Your ref:  
Our ref: LTR-NRC-02-60

Subject: Response to RAI on the "Topical Report on Modular Accident Analysis Program Version 5 (MAAP5) Pressurized Water Reactor (PWR) Large Dry Containment Model," WCAP-15844

## 2.0 MAAP5 Topical Report

Figure 1: Comparison of the MAAP5 calculated free and forced convection heat transfer and the experimental data reported by Kuhn et al.

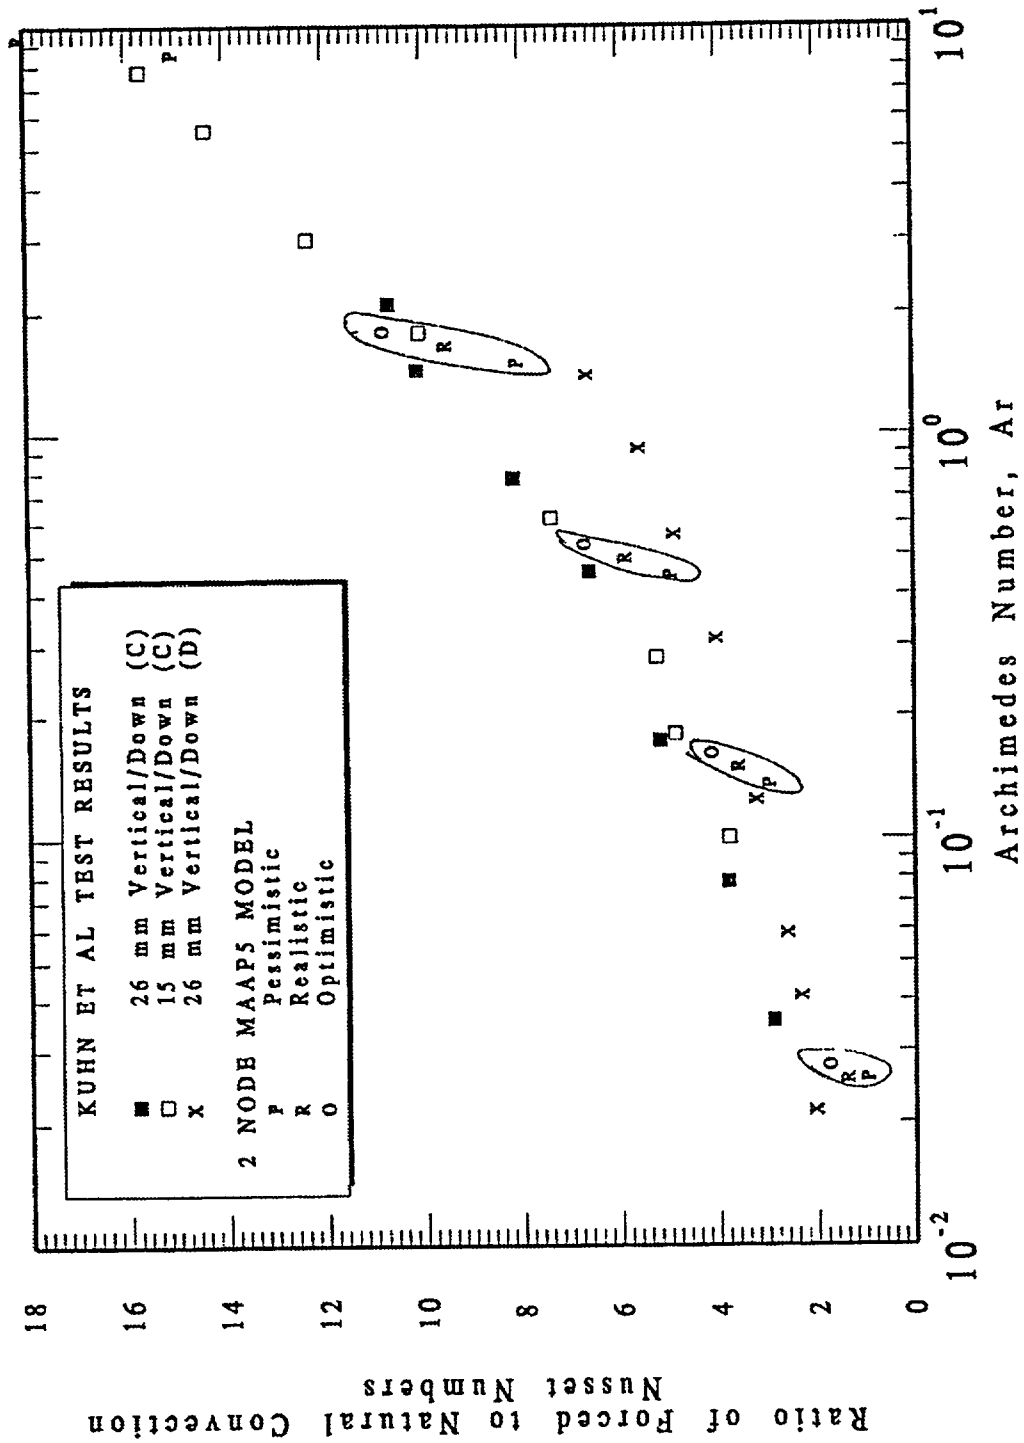
**Item 2.2.5. What is the justification for using the Dittus-Boelter or any other one-dimensional heat transfer correlation with the  $\square$  momentum-driven velocity  $\square$  derived as having a property value with no directional dependence? Same question for entrainment correlations?**

As additional justification for considering the "momentum-driven velocity" as a characterization of the free stream velocity to be used in correlations describing the rates of heat, mass and momentum transfer, a benchmark has been performed with enclosure experiments reported by Kuhn et al. (Kuhn, S. Z., Kang, H. K. and Peterson, P. F., 2002, "Study of Mixing and Augmentation of Natural Convection Heat Transfer by A Forced Jet in a Large Enclosure," Trans. of the ASME, Journal of Heat Transfer, Vol. 124, pp. 660-666). In these experiments, a gas jet was injected into an enclosure and an equal mass flow rate was exhausted through another port. The influence of the induced flow by the jet was characterized in terms of a ratio of the enhanced convective Nusselt number divided by the natural convection Nusselt number as a function of the Archimedes number (defined as the jet Reynolds number squared divided by the Grashof number based upon the enclosure diameter). Of particular interest in the MAAP benchmark, are the tests in which the air jet was injected vertically downward into the center of the enclosure or next to the enclosure wall. The jet flow induced a significant momentum-driven velocity as reflected by the augmented heat transfer from the heated bottom surface. (The continuity velocity in these experiments is of the order 1.0 mm/sec which is far less than the velocities required to explain the enhanced heat transfer.) Figure 1 compares the optimistic, realistic and pessimistic values for the enhanced heat transfer calculated by the MAAP5 model. It is to be remembered that the pessimistic value (that designated by the P in the attached figure) is the value that is used in evaluating the containment peak pressure and temperature response.

As illustrated, there is agreement between the enhanced forced convection heat transfer coefficients in these enclosure tests and those calculated by the MAAP model.

Figure 1

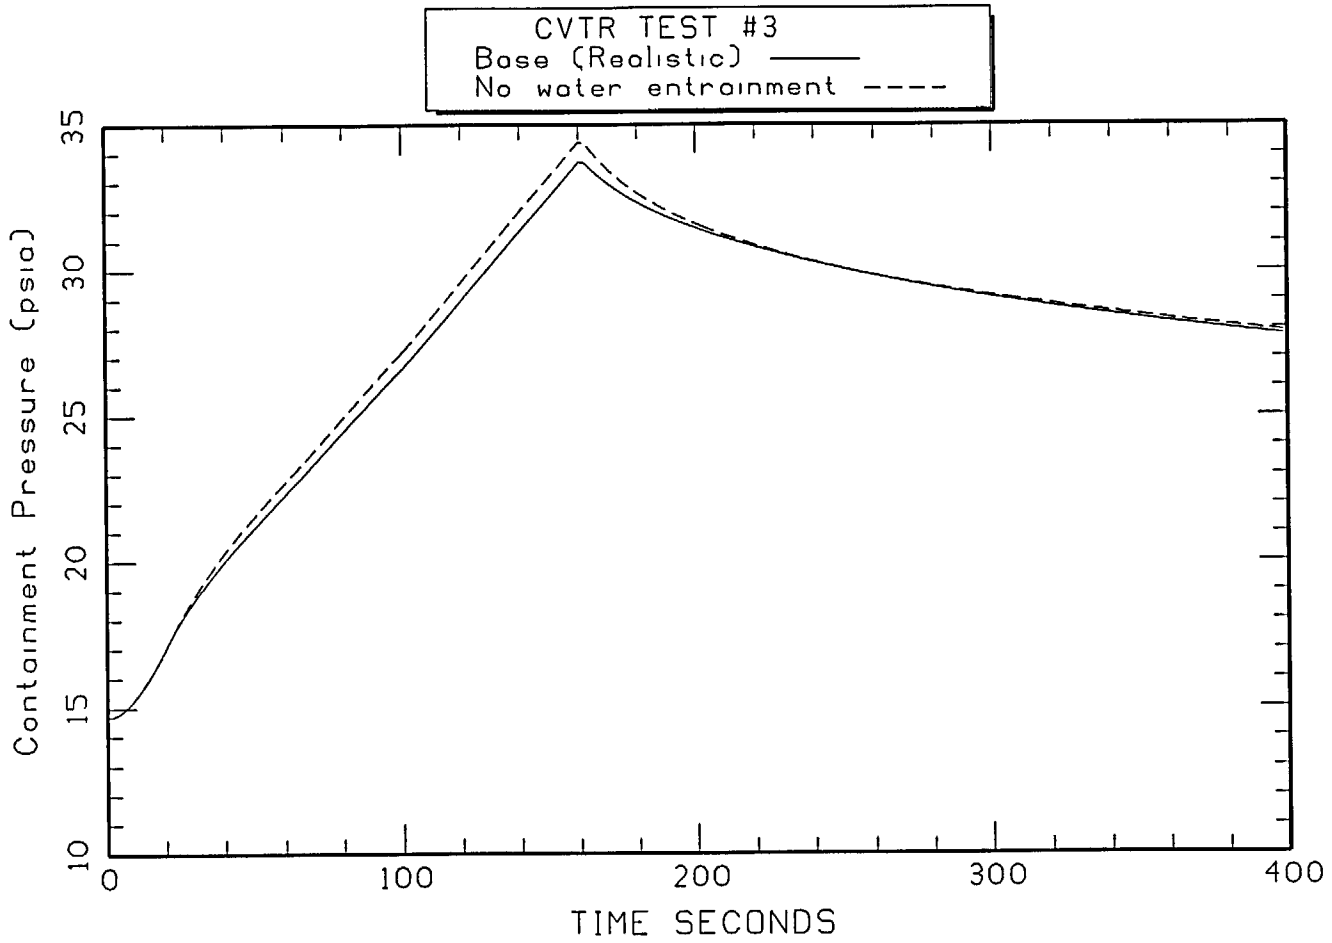
**Item 2.2.8. To what degree does water entrainment enter into the CVTR calculation?  
Provide a water entrainment time history profile in compartments for test 3.**

The impact on the containment pressure and gas temperatures of water entrainment are shown in the attached plots for the CVTR test #3. The peak pressure (Figure 1) increases about 0.7 psi when water entrainment is not credited. The peak gas temperature in the node 1 (Figure 2) increases about 25°F without the water entrainment. Figure 3 illustrates that entrainment is occurring only in node #2 which is receiving all of the break discharge in this calculation.
